7-ELEVEN AT VALLEY PLAZA SITE PLAN & CONDITIONAL USE

LOT 4 - BLOCK 1 VALLEY PLAZA SUBDIVISION FILING NO. 1
 LOCATED IN THE NORTHWEST QUARTER OF SECTION 9, TOWNSHIP 5
 SOUTH, RANGE 66 WEST OF THE 6TH P.M., CITY OF AURORA, COUNTY
 OF ARAPAHOE, STATE OF COLORADO

7-ELEVEN SITE PLAN

P0.0
SHEET 1 OF 13

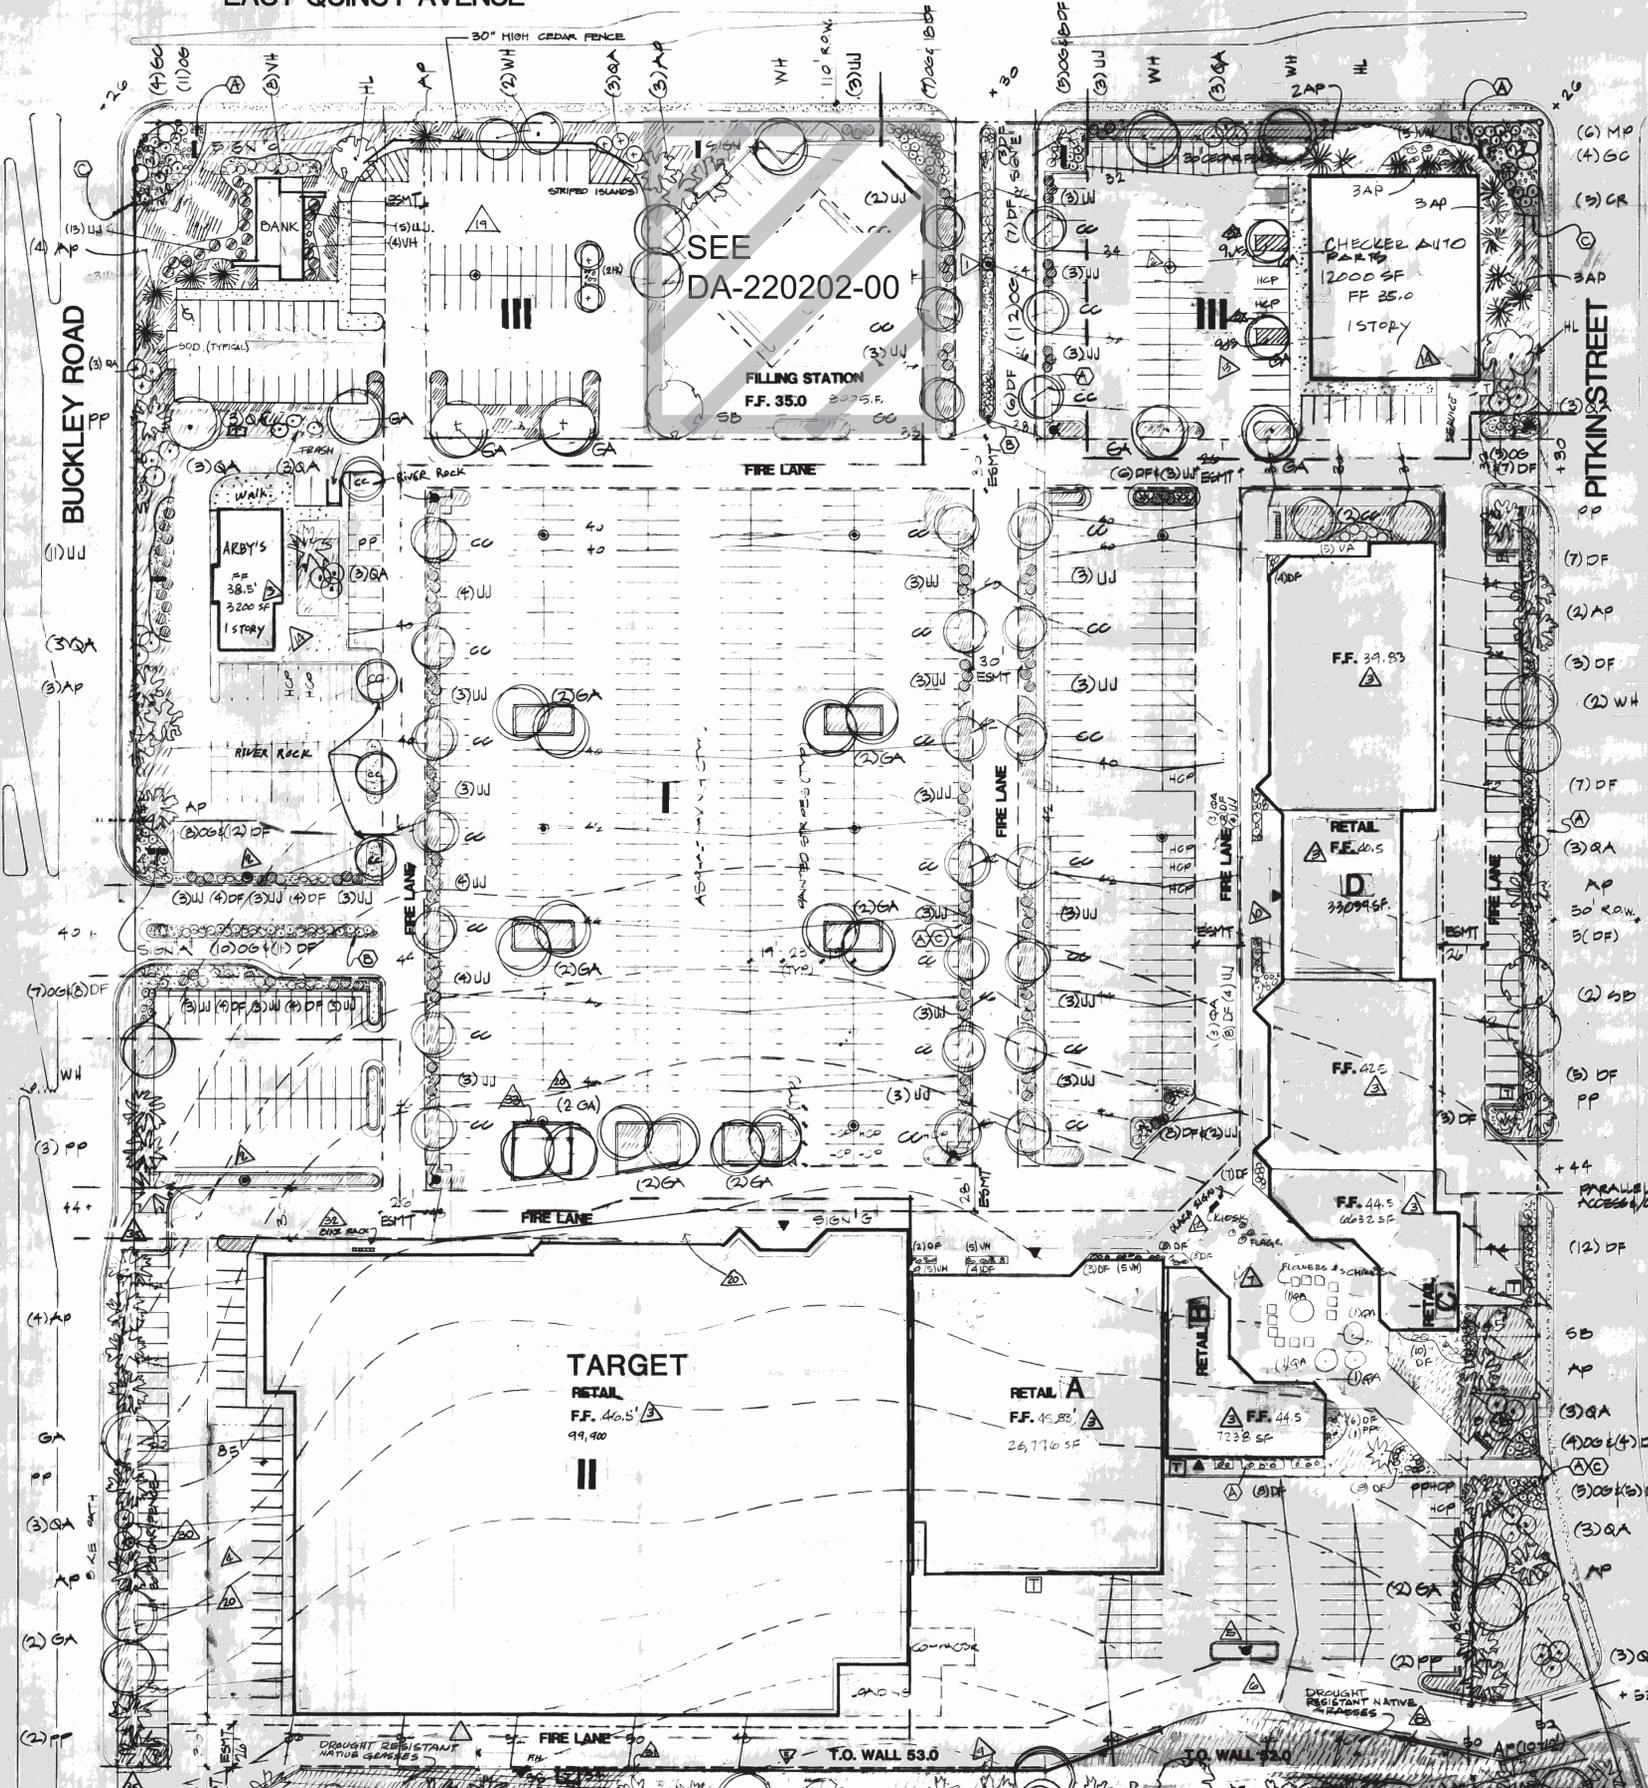
The site plan will not be approved by public works until the preliminary drainage letter/report is approved

Comments were provided 12/27/2019 and no subsequent submittal has been made. Please do not resubmit the site plan until another review of the drainage letter has been completed

Please remove AutoCad SHX text items in the comment section. Please flatten to reduce select-ability of the items.

Change to Adjustment. The city no longer uses the term waivers.

Please add number of bicycle racks provided to data block.

Add this note:
 THE 2015 INTERNATIONAL FIRE CODE, SECTION 510, REQUIRES ALL BUILDINGS TO BE ASSESSED FOR ADEQUATE EMERGENCY RESPONDER RADIO COVERAGE (ERRC). AT THE TIME THE STRUCTURE IS AT FINAL FRAME AND FINAL ELECTRICAL INSPECTIONS, THE GENERAL CONTRACTOR (GC) WILL BE REQUIRED TO HIRE AN APPROVED AND QUALIFIED INDEPENDENT 3RD PARTY TO ASSESS THE RADIO FREQUENCY LEVELS WITHIN THE STRUCTURE. ONCE COMPLETED, THE 3RD PARTY WILL PROVIDE THE RESULTS OF THE TEST TO BOTH THE GC AND THE AURORA BUILDING DIVISION AS TO WHETHER THE STRUCTURE PASSED OR FAILED THE PRELIMINARY RADIO SURVEILLANCE. A STRUCTURE THAT HAS PASSED THIS SURVEILLANCE REQUIRES NO FURTHER ACTION BY THE GC. A FAILED RADIO SURVEILLANCE WILL REQUIRE A LICENSED CONTRACTOR TO SUBMIT PLANS TO THE AURORA BUILDING DIVISION TO OBTAIN A BUILDING PERMIT FOR THE INSTALLATION OF AN ERRC SYSTEM PRIOR TO INSTALLATION. THIS ASSESSMENT AND INSTALLATION IS AT THE OWNER OR DEVELOPER'S EXPENSE. FUTURE INTERIOR OR EXTERIOR MODIFICATIONS TO THE STRUCTURE AFTER THE ORIGINAL CERTIFICATE OF OCCUPANCY IS ISSUED WILL REQUIRE A REASSESSMENT FOR ADEQUATE RADIO FREQUENCY COVERAGE.

Provide heights of both structures; separate these structures within the data block

Please provide sf for car wash; separate these structures in the DATA BLOCK.

**EES RESPONSE:
PRELIMINARY
DRAINAGE REPORT
WAS SUBMITTED
PRIOR TO SITE
PLAN RESUBMITTAL**

**EES RESPONSE:
ACKNOWLEDGED
AND COMPLETED**

**EES RESPONSE:
NOTE UPDATED**

**EES RESPONSE:
NOTE ADDED**

**EES RESPONSE:
ADDED**

**EES RESPONSE:
ADDED**

7-ELEVEN SITE PLAN
16820 E. QUINCY AVENUE, AURORA, CO 80011
LANDSCAPE COVER
SHEET & PLANT LIST

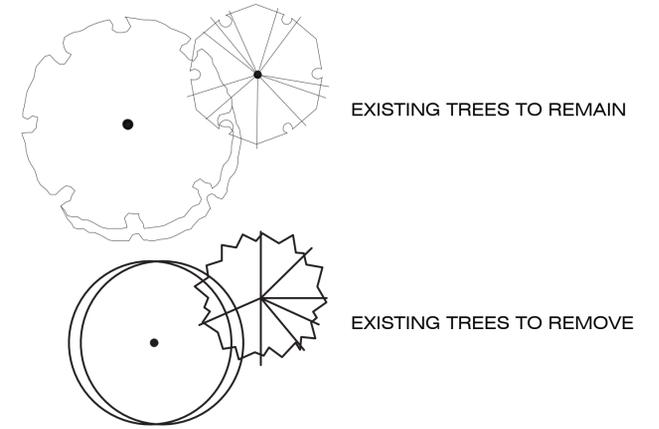
Add an asterisk and a note at the bottom of the table that states that one tree is existing.

Because code requires 50% to be evergreen, add an asterisk and note explaining this. See comment on landscape plan.

Along with the table, include a plan that delineates the water and non-water conserving areas by hatches and/or shading.

Add a note that states any existing trees that may die or are removed that are being used to meet UDO requirements shall be replaced so as to be compliant with the approved landscape plan.

See landscape plan for how building perimeter lengths were determined.

EES RESPONSE: UPDATED

EES RESPONSE: UPDATED

EES RESPONSE: UPDATED

EES RESPONSE: UPDATED

EES RESPONSE: UPDATED

7-ELEVEN SITE PLAN
 16820 E. QUINCY AVENUE, AURORA, CO 80011
 TREE INVENTORY PLAN

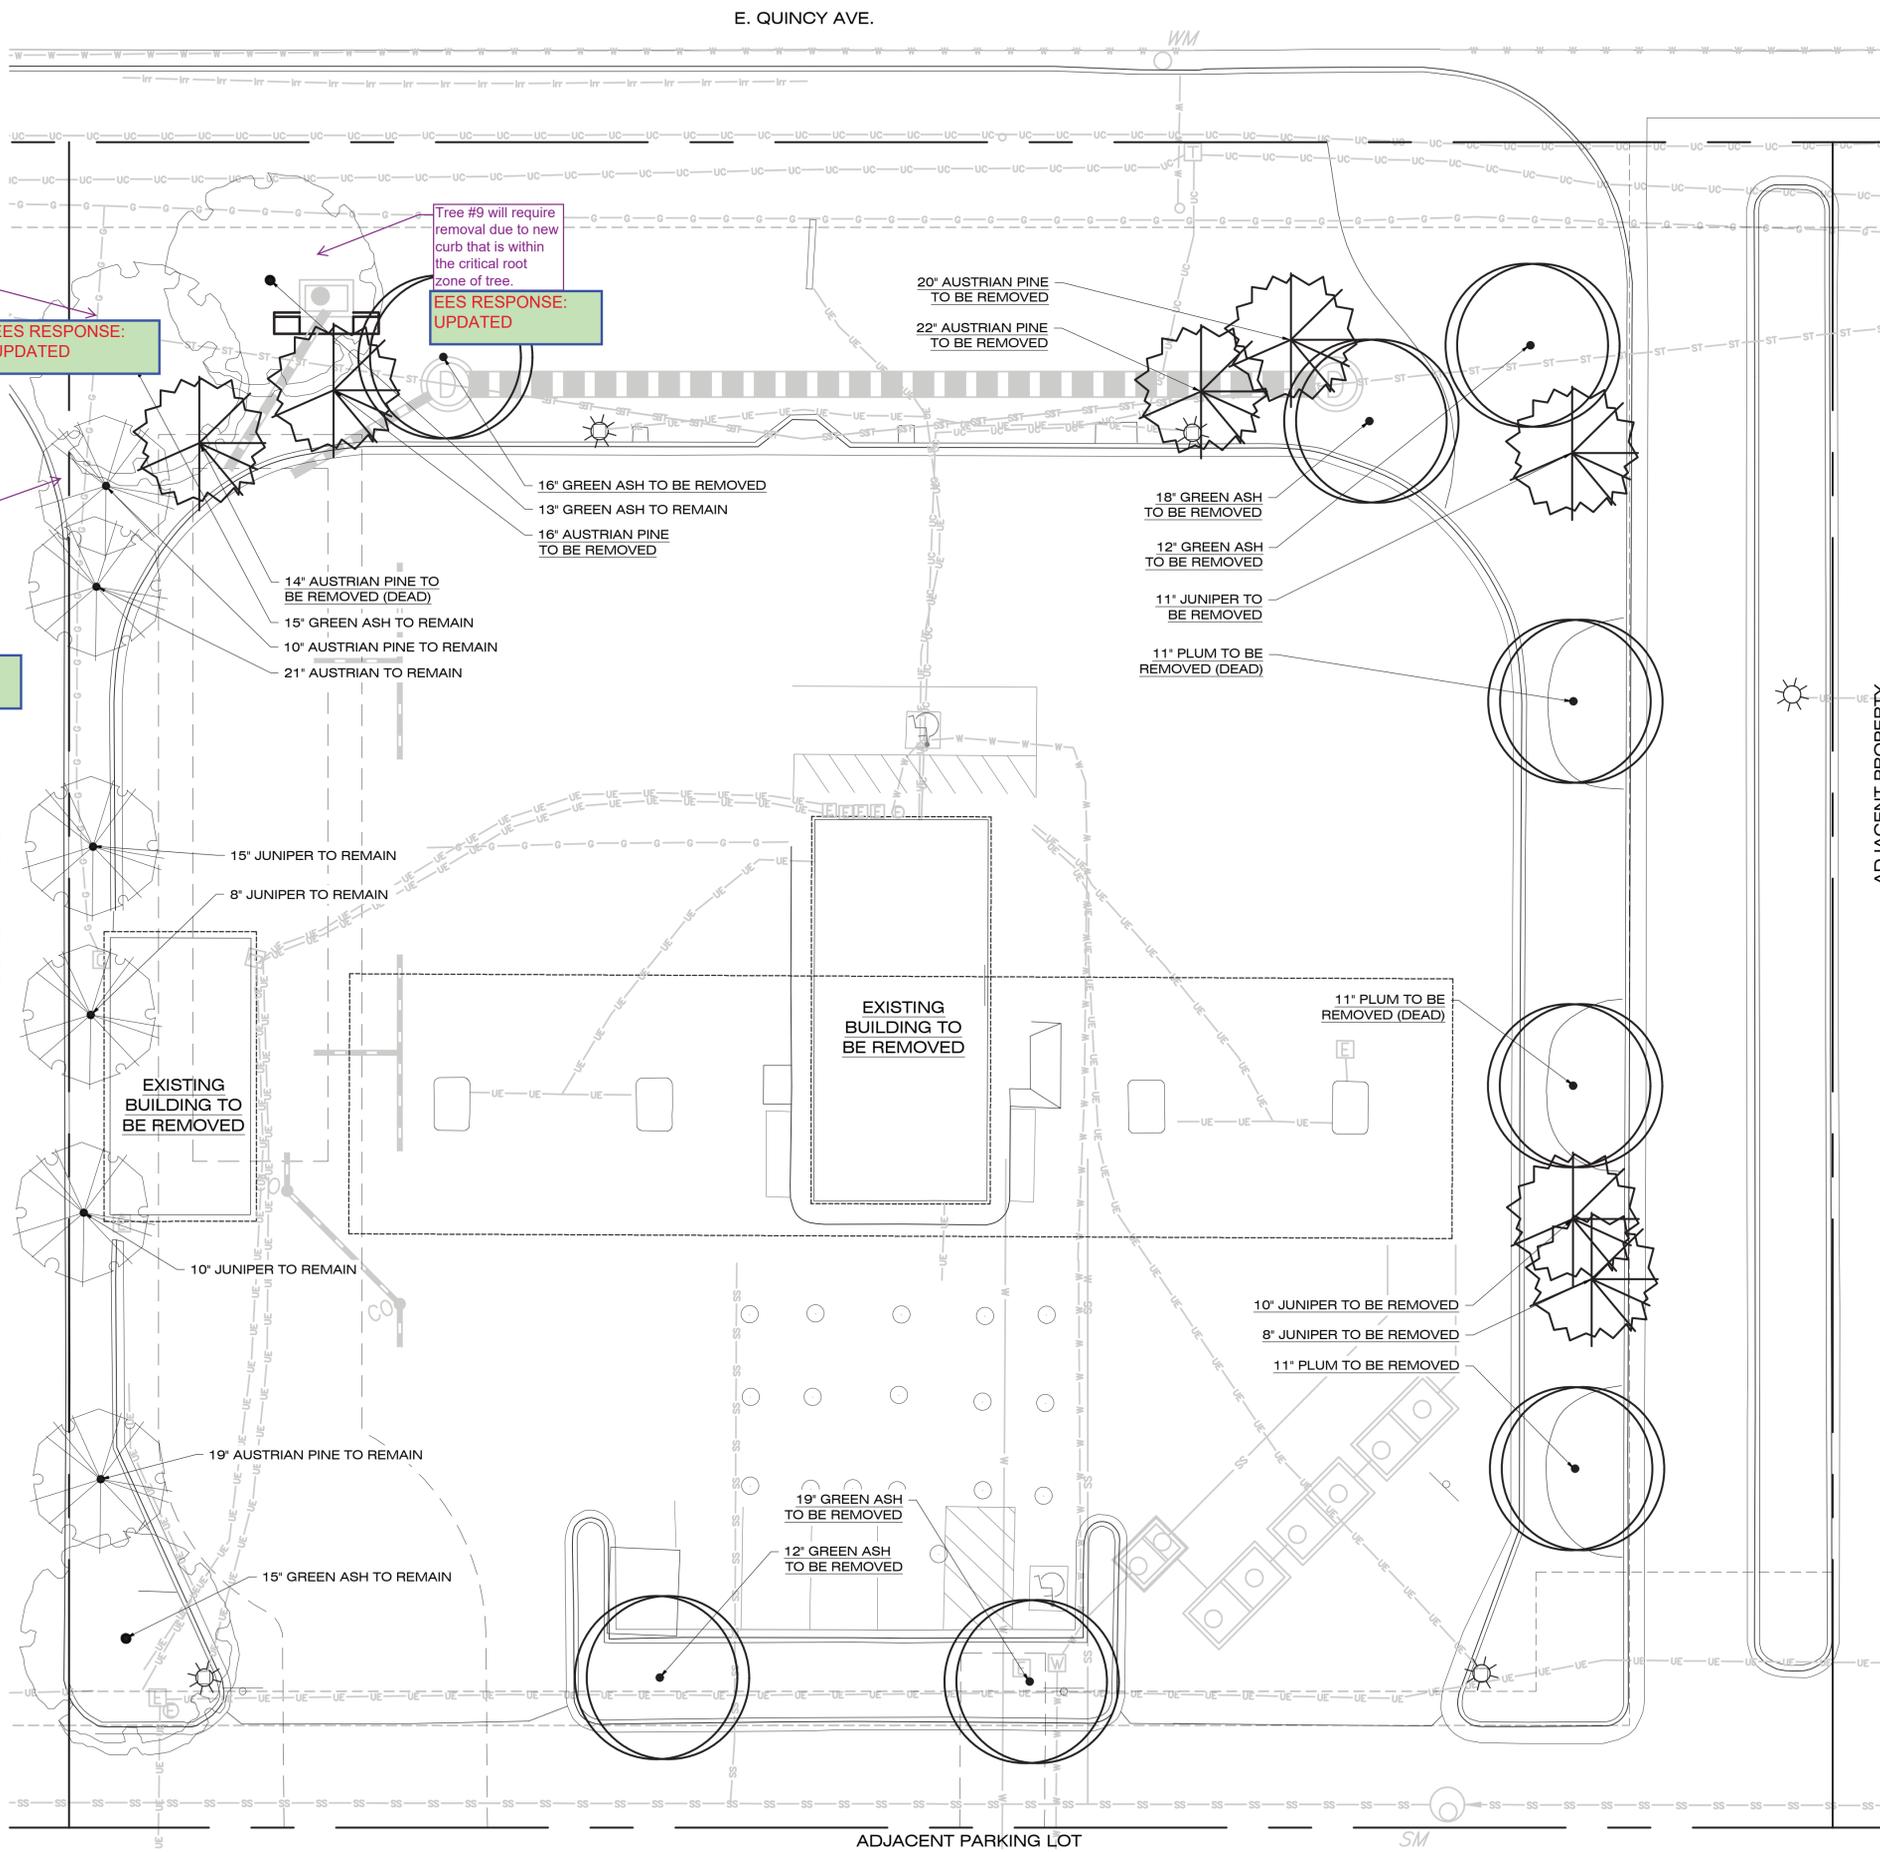
Update Community Tree Fund to reflect additional removals

EES RESPONSE: UPDATED

EES RESPONSE: UPDATED
